Tech. Cust. Service VKT 20 Gi/Zr/Go	Motorcycles R 50/5, R 60/5, R 75/5 Gr.: Suspension and shock absorbers	Munich, Jan. 71 No. 2/70 (293) e.

Ref.: Castor correction at the installation of shells

chart on
reverse side

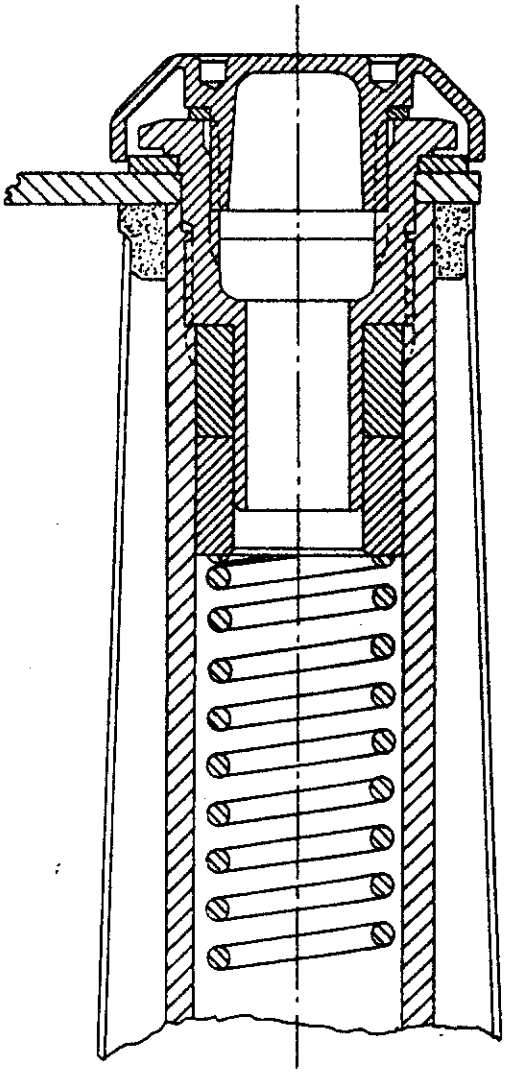
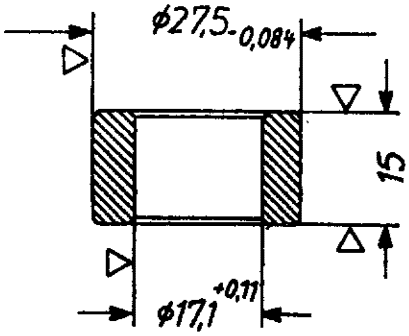
when installing shells, the castor is smallered by the higher front axle boad and the greater spring way of the fork. To reach the original castor again, put each two washers, ordering No. 31 42 2 000 399 under the upper spring bearing of both fork legs, see chart.

If you produce these washers by yourself use as material Aluminium, steel or oilproof plastics as Nylon, Pertinax or Novotex.
